SUBJECT: RIVER BEND STATION, UNIT 1 - ISSUANCE OF AMENDMENT RE:
CORRECTION OF A NON-CONSERVATIVE TECHNICAL SPECIFICATION
FOR PRESSURE-TEMPERATURE LIMITS (EPID L-2018-LLA-0083)

Amendment No. 195
Renewed License No. NPF-47

SAFETY EVALUATION BY THE OFFICE OF NUCLEAR REACTOR REGULATION

RIVER BEND STATION, UNIT 1

Figure 3.4.11-1 (page 1 of 1)
Minimum Temperature Required vs. RCS Pressure
Without Uncertainty for Instrumentation Error

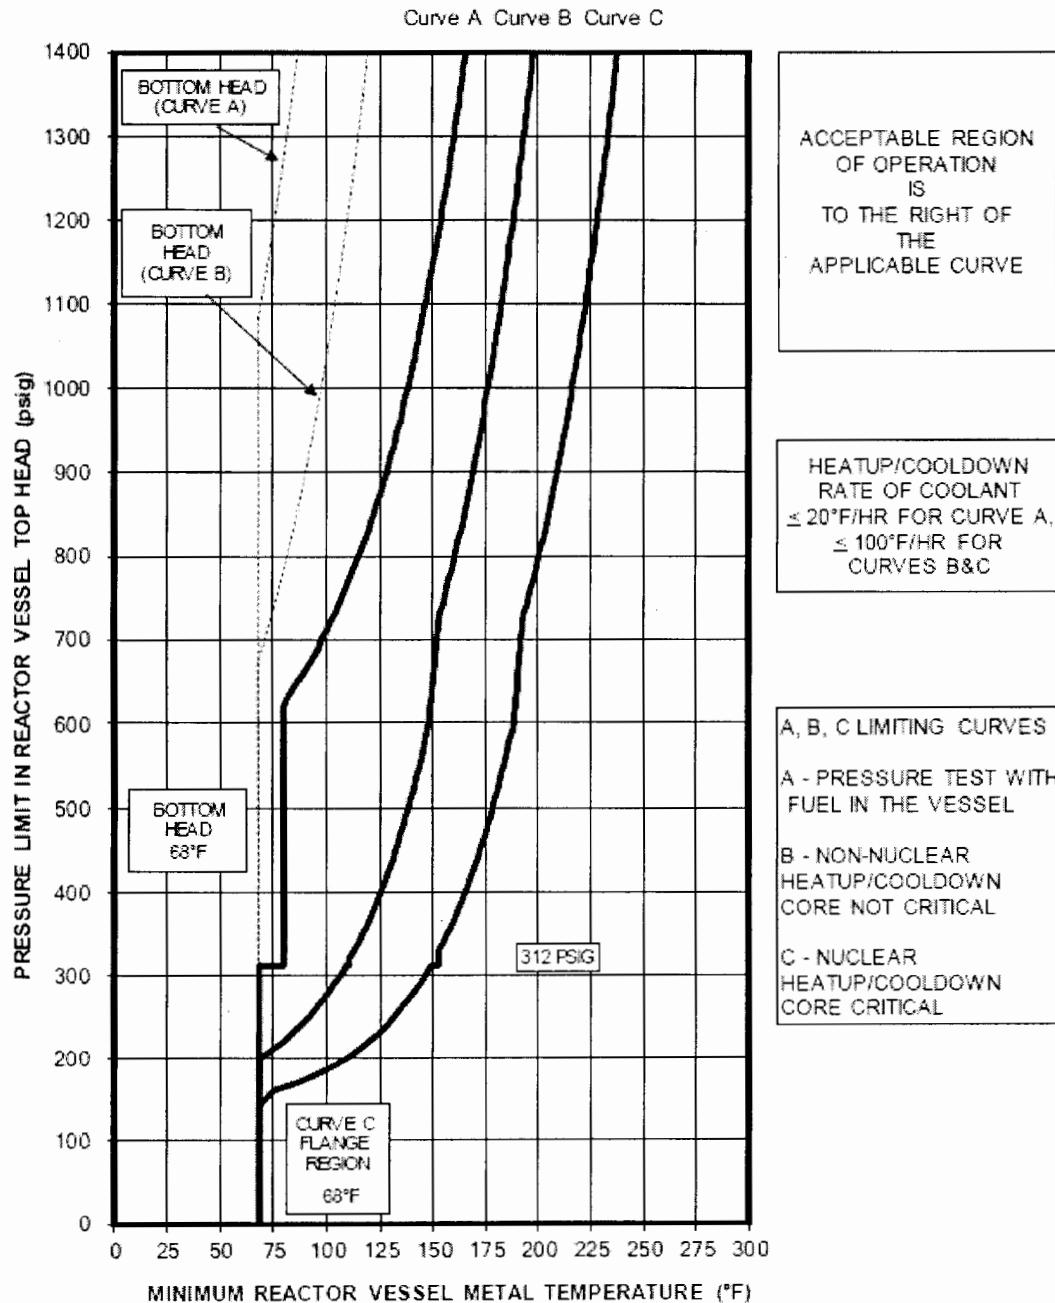
The amendment revises the River Bend TS Figure 3.4.11-1, "Minimum Temperature Required vs. RCS [Reactor Coolant System] Pressure," for reactor heatup, cooldown, and critical operations as well as for inservice leak tests and hydrostatic tests. This change replaces the non-conservative curve, which is for 32 Effective Full Power Years (EFPY) with a new curve that is for 54 EFPY.

In the LAR dated April 2, 2018, Entergy identified that the existing P-T limits for Curves B and C at 32 EFPY were determined to be non-conservative based on a GEH assessment. The licensee stated that the P-T limit curves for 32 EFPY approved in License Amendment No. 120, inadvertently omitted the effects of the **[[** discontinuity on the stress intensity factors for assessed RPV beltline components in the year 2000 P-T limits submittal. **]]** The licensee stated that the updated P-T limit curves for 54 EFPY, submitted in the application, propose to resolve the non-conservatism. The licensee took this action in accordance with the NRC staff position in NRC Administrative Letter (AL) 98-10, "Dispositioning of Technical Specifications Insufficient to Assure Plant Safety" (Reference 9). This AL provides the NRC staff position on the discovery of non-conservative TS requirements in the licensing basis, and the corrective actions that may be applied by a licensee. The long term corrective action to be taken by the licensee upon the discovery of a non-conservative or non-conforming TS requirement is to submit an LAR to the NRC.

The NRC staff observed that the revision to TS Figure 3.4.11-1 included a statement that the P-T limit curves were developed "~~[[~~
~~]]~~." The NRC staff requested the licensee to account for ~~[[~~
~~]]~~ for 54 EFPY.

However, the NRC staff observed that by adding new P-T limit curves for the RPV bottom head into TS Figure 3.4.11-1, the specific SR statements in TS 3.4.11.1 could become unclear because the TS SR section does not define how or when the licensee should perform specific types of P-T monitoring activities against the new P-T limit curves for the bottom head (i.e., those for Service A and B loading conditions) versus those for the RPV beltline region under Service A and B loading conditions.

During its review, the NRC staff could not verify that the proposed P-T limit curves for the RPV beltline region under Service B and C loading conditions would meet the requirement in 10 CFR Part 50, Appendix G, for incorporating appropriate conservatism in P-T limit calculations. Specifically, the NRC staff noted the plant-specific basis for assessing the []

In the letter dated October 4, 2018 (Reference 2), the licensee stated that the treatment of ~~[[~~
~~]]~~ will be addressed in an update of River Bend Procedure STP-050-0700, "RCS Pressure/Temperature Limits Verification," which will be tracked through an item in the licensee's Paperless Condition Reporting System (PCRS). The NRC staff finds this approach to be an acceptable alternative regarding the treatment of ~~[[~~
~~]]~~ for 54 EFPY.

In the letter dated October 4, 2018, the licensee stated that River Bend Procedure STP-050-0700, is used to meet the TS SR requirements associated with the P-T limit curves in TS Figure 3.4.11-1. The licensee clarified that the current version of the procedure only includes criteria for monitoring RCS temperatures in the vicinity of the beltline region of the RPV. However, the licensee stated that, with the implementation of P-T limit curves for both the beltline and bottom head regions of the RPV, the procedure will be updated to require RPV beltline and bottom head temperature monitoring be performed in relation to the corresponding P-T limit curve for the RPV location in the updated TS figure. The licensee stated that the changes to the procedures will be tracked through the site-specific PCRS. The NRC staff finds that since the procedural changes will be tracked by the PCRS and will be subject to applicable criteria in the licensee's 10 CFR Part 50, Appendix B, quality assurance program, these SR monitoring criteria do not need to be accounted for through a proposed change to the provisions in TS SR Section 3.4.11.1. The NRC staff also finds that the current version of TS SR Section 3.4.11.1 is adequate without any need to amend the existing TS SR section by the licensee.

By letter dated October 4, 2018 (Reference 2), the licensee stated that use of an []

The NRC staff determined that the licensee's response provided sufficient justification for applying [] to the P-T limit thermal stress evaluation of the [] because they are based on the NRC staff-endorsed methodology in WRC Bulletin No. 175. The NRC staff also determined that the P-T limit curves proposed for the RPV beltline region under Service B and C loading conditions are acceptable because they meet the requirements in 10 CFR Part 50, Appendix G, and the safety margin requirements in ASME Code Section XI, Appendix G, including those specified in the ASME appendix for RPV nozzle appurtenance assessments. Based on this review, the NRC staff finds that the licensee may implement the proposed P-T limit curves for 54 EFPY that apply to the RPV beltline region under Service B and C loading conditions, with a maximum allowable 100 °F/hr restriction on RCS temperature rate changes associated with these types of operations.

In the letter dated October 4, 2018 (Reference 2), the licensee stated that the plant-specific RPV bottom head dimensions are an [] [] and a [] []. The licensee also stated that, based on these dimensions, the plant-specific [] []. The NRC staff noted that these site-specific dimensions provide sufficient demonstration that the plant-specific [] [] for the RPV bottom head is bounded by the [] [] in GEH Report No. NEDC-33178P-A, and that the generic methodology may be used to establish the P-T limit curves for the RPV bottom head.

Based on the generic methodology and the applicable site-specific information, the NRC staff has verified that the proposed P-T limit curves for the RPV bottom head under Service Level A and B loading conditions are conservative and acceptable because the licensee has sufficiently demonstrated that the P-T limit curves for the RPV bottom head will meet the requirements of 10 CFR Part 50, Appendix G, and the safety margins specified in ASME Code Section XI, Appendix G, through 54 EFPY. Further, the NRC staff determined that the changes will allow the TS to continue to meet the regulatory requirements of 10 CFR 50.36(c)(2) for LCOs and 10 CFR 50.36(c)(3) for SRs. Based on its review, the NRC staff finds that the licensee may implement the proposed P-T limit curves for 54 EFPY that apply to the RPV bottom head region under Service A and B loading conditions, with a maximum allowable 20 °F/hr restriction on RCS temperature rate changes associated with the Service Level A pressure test operations and a maximum allowable 100 °F/hr restriction on RCS temperature rate changes associated with the Service Level B non-critical power operations.
